Final Initial Study and
Mitigated Negative Declaration
for the San Antonio Water Company's
Proposed Cucamonga Crosswalls Maintenance Project
City of Upland, San Bernardino County, California
(EAR-0028)

Section	Page
1 Introduction	1
2 Comments Received	3
3 Errata/Revisions to the Draft Initial Study	41
4 Mitigation Monitoring and Reporting Program	43

Overall Project Site Plan
Cucamonga Crosswalls Maintenance Project

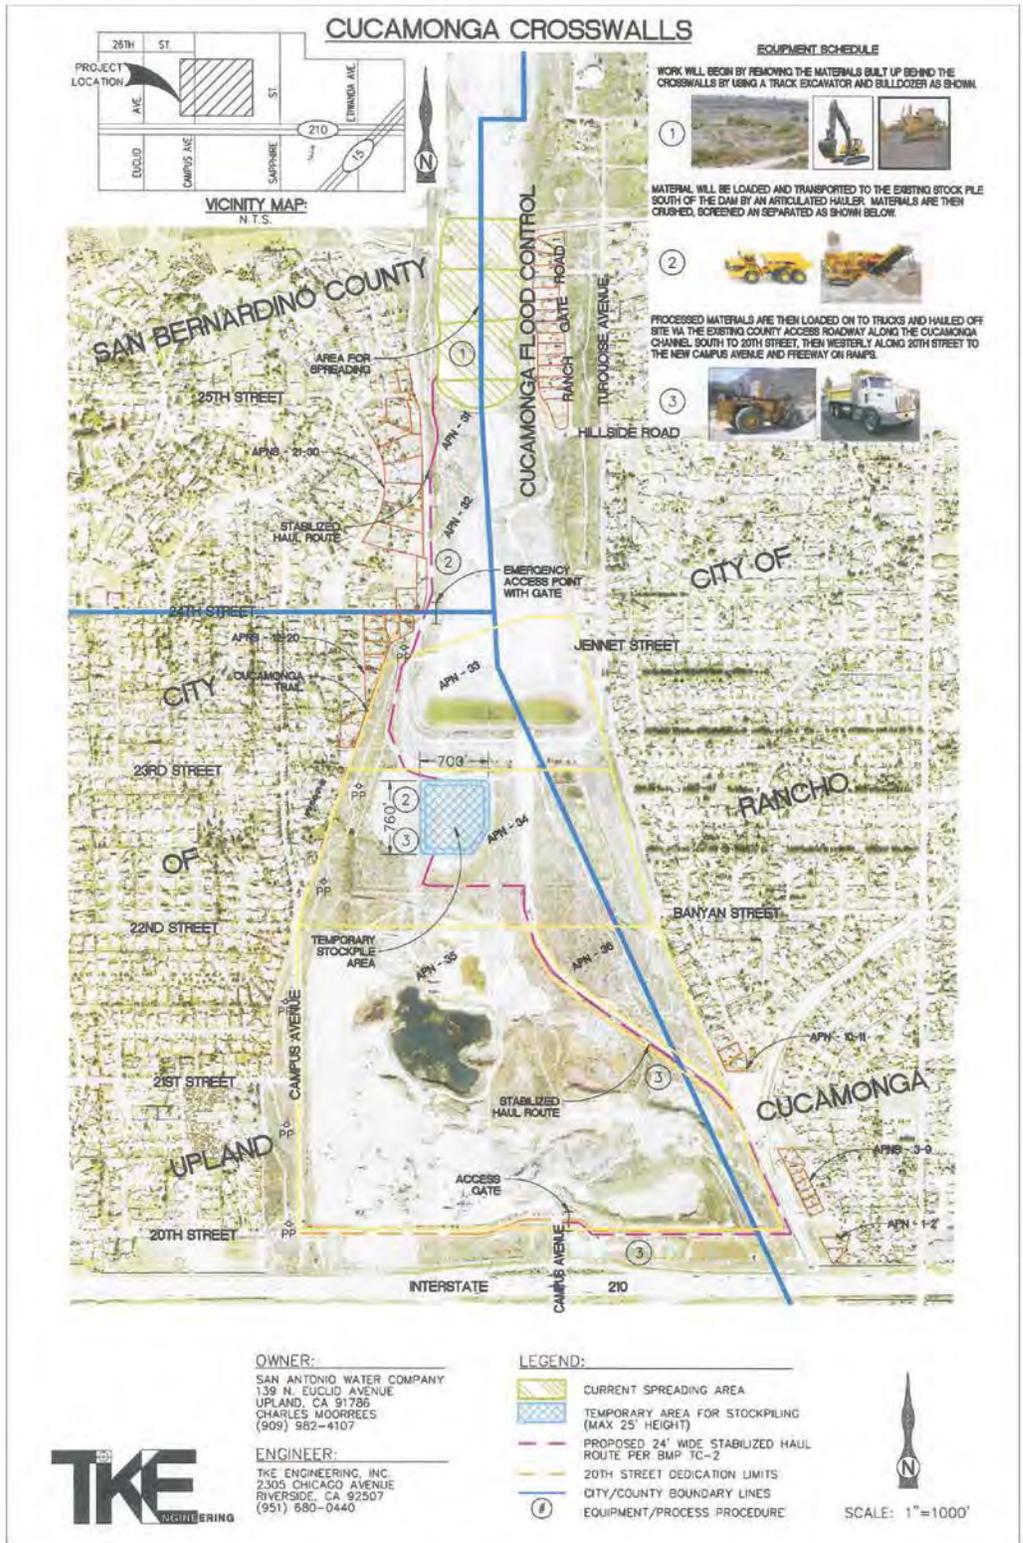
Cucamonga Creek Debris Dam, No. 87-9, is currently under our jurisdiction for dam safety. Based on the information provided, the work described is considered routine maintenance and will not affect the safety of the dam. Therefore, no application will be required, provided that construction activities will not impact the dam or modifications are not made to the dam or its ancillary structures. Please notify Area Engineer Eric Wulff at (916) 227-5477 prior to implementation of this project so that we may have the opportunity to observe the work.

If the work will entail any modifications to the dam or its ancillary structures, an application filed in duplicate, together with plans, specifications, and the appropriate filing fee must be filed with the Division of Safety of Dams. All dam safety related issues must be resolved prior to approval of the application, and the work must be performed under the direction of a Civil Engineer registered in California. Sharon Tapia, our Design Engineering Branch Chief, is responsible for the application process and can be reached at (916) 227-4660.

Response 4-1 The maintenance and repair of the crosswalls will be done further upstream away from the dam. In addition, the proposed haul road takes trucks around the dam so that no trucks will traverse the dam. In addition, the proposed activities will occur approximately ½ mile north of the dam as shown in the attached exhibit.

Response 4-2 See response to comment 4-1 regarding dam modifications.
